Well Name: GOLD MEDAL	Well Location: T24N / R10W / SEC 33 / SWSW / 36.26448 / -107.90694	County or Parish/State: SAN JUAN / NM
Well Number: 4	Type of Well: OIL WELL	Allottee or Tribe Name:
Lease Number: NMNM22044	Unit or CA Name:	Unit or CA Number:
US Well Number: 300452677900S1	Operator: DUGAN PRODUCTION CORPORATION

Type of Submission: Notice of Intent	Type of Action: Plug and Abandonment
Date Sundry Submitted: 12/02/2025	Time Sundry Submitted: 01:49
Date proposed operation will begin: 12/08/2025

Notice of Intent – Plug and Abandonment

Operator: Dugan Production Corporation
Lease: NMNM 022044
Well(s): Gold Medal 4, US Well # 30-045-26779
Location: SWSW Sec 33 T24N R10W (San Juan, NM)
Sundry Notice ID #: 2884910

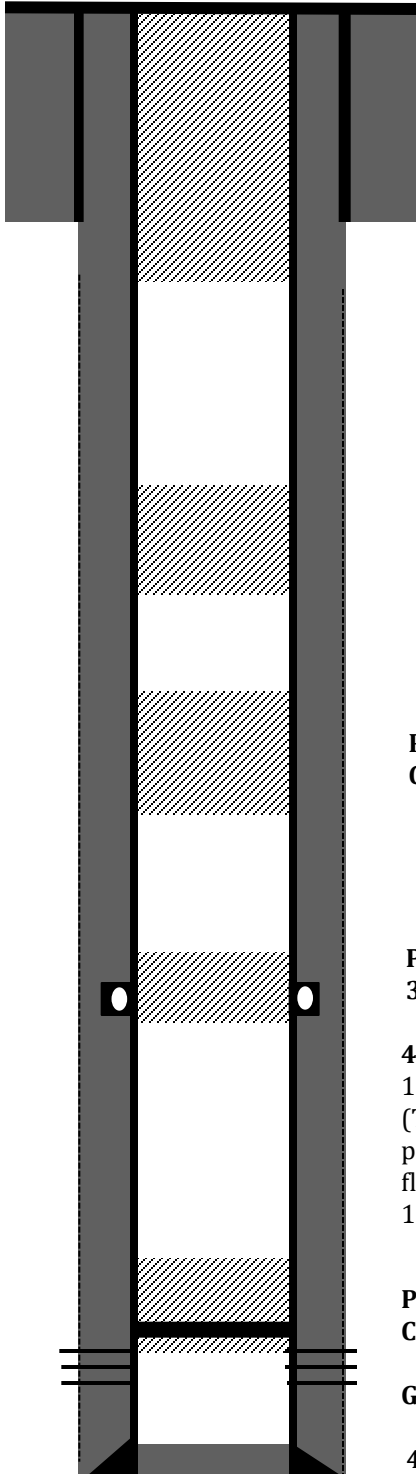
1. Plugging operations authorized are subject to the attached "General Requirements for Permanent Abandonment of Wells on Federal and Indian Lease."
2. The following modifications to your plugging program are to be made:
 - a. Modify Plug 3 to account for the BLM geologist's for the Cliff House at 2127'. Move the BOC to 2177'.
 - b. Modify Plug 4 to account for the BLM geologist's for the Fruitland at 580'. Move the TOC to 480'.
 - c. Modify Plug 5. Make the BOC 340' to account the BLM geologist's pick for the Kirtland at 290'.
3. **Notification:** Farmington Office is to be notified at least 24 hours before the plugging operations commence at (505) 564 7750.

-Modify Plug 3 to account for the BLM geologist's pick for the Cliff House. Move the BOC to 2177'.

-Modify Plug 4 to account for the BLM geologist's pick for the Fruitland. Move the TOC to 480'.

-Modify Plug 5. Make the BOC 340' to account the BLM geologist's pick for the Kirtland.
